## **REMEDIATION SYSTEM EVALUATION (RSE)**

### **CENTRAL CITY/CLEAR CREEK SUPERFUND SITE ARGO TUNNEL WATER TREATMENT PLANT IDAHO SPRINGS, COLORADO**

Report of the Remediation System Evaluation  
Site Visit Conducted May 16, 2007

Final Report  
September 2007

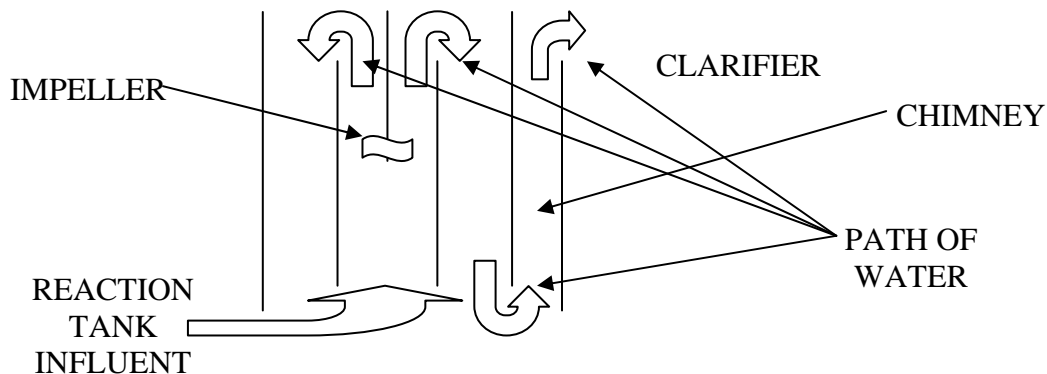
Potassium permanganate addition and greensand filters were considered earlier in the design but were eliminated from consideration due to the cost of reagents. The estimated cost for potassium permanganate was over \$400,000 per year to achieve oxidation of the manganese. However, this analysis was done on the treatment system influent and the amount of potassium permanganate was based on the total influent of manganese to the plant rather than the manganese that was present in the effluent of the clarifier. The site team currently operates the metals removal system at pH 10.1 and has tried to reduce it in the past but could not meet the manganese discharge standard of 800 ug/L at a lower pH. Under this approach, the site team would reduce the pH to various set points and monitor the manganese levels in the clarifier effluent. As the pH decreases, less lime will be required, less sludge will be generated, and less scaling will occur on the filters. However, the manganese levels will increase requiring an increased level of potassium permanganate and greensand. The savings associated with this approach are difficult to calculate. Testing may indicate that savings in reduced sludge disposal, lime usage, and hydrochloric acid usage are offset by potassium permanganate costs. A 90% reduction in the manganese concentrations by metals precipitation would result in permanganate costs of \$40,000 per year. The costs of permanganate would likely offset the savings from reduced lime usage and sludge generation.

The primary reduction in sludge volume would likely result from a decrease in the production of magnesium hydroxide. Sludge volumes have not increased as a result of the transition from using caustic to lime, suggesting that the use of lime is not adding to sludge volume. It is noted that magnesium concentrations decrease from approximately 120 mg/L in the influent to approximately 40 mg/L in the effluent. Because magnesium hydroxide typically forms at a higher pH, a reduced pH should decrease the amount formed. The primary reduction in scaling would result from lower calcium concentrations in the clarifier effluent. The product of the current calcium and sulfate concentrations exceed the solubility product for calcium sulfate, suggesting that it may be contributing to filter scaling. Furthermore, scaling was not an issue when caustic was used for pH adjustment.

The cost for implementing this approach may be as high as \$350,000 to pilot this approach, remove the existing filters and replace them with greensand filters with a total hydraulic capacity of over 700 gpm, and add air scour capability for backwashing. Given the substantial capital cost and the negligible savings, this approach should only be considered if other approaches to resolving the filter scaling are unsuccessful or if the site team is confident that substantially lower permanganate use would be required than assumed here.

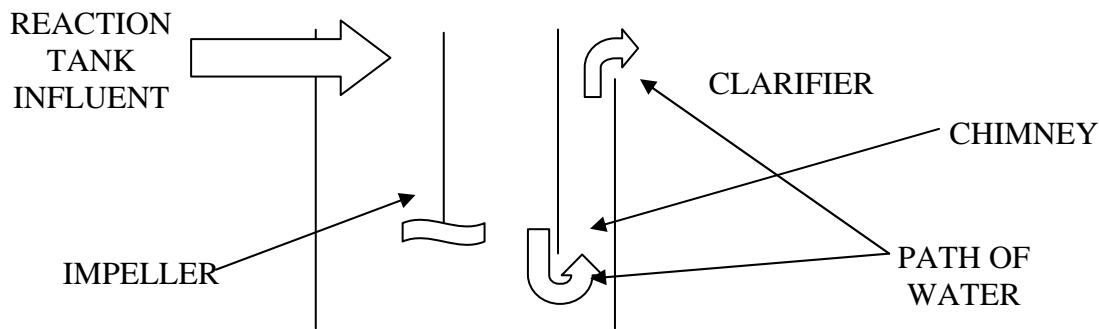
With the current reaction tank design, water must flow up past the impeller in the center of the tank, over a baffle into the outer portion of the tank, down to the bottom of the tank, and then up the entire height of the tank over a baffle into the clarifier (see figure below).

This is a relatively tortuous path for the solids-laden water to travel. Typically, a baffle is provided to prevent the turbulence associated with mixing from affecting the clarifier; however, this design appears to include additional separation. Solids settling within the chimney might be greatly reduced if the inner walls of the reaction tank were removed and the baffle between the tank and the chimney was raised/shortened so that the mixing of the impeller would prevent solids from settling in the tank and the upward path to the clarifier is shortened. The influent location and impeller and mixer design may need to be modified to provide adequate mixing in this larger tank volume. A figure of the potential revised design is shown below.

If this approach is not possible, the site team might consider adding additional mixing or turbulence to the existing chimney area to prevent settling.
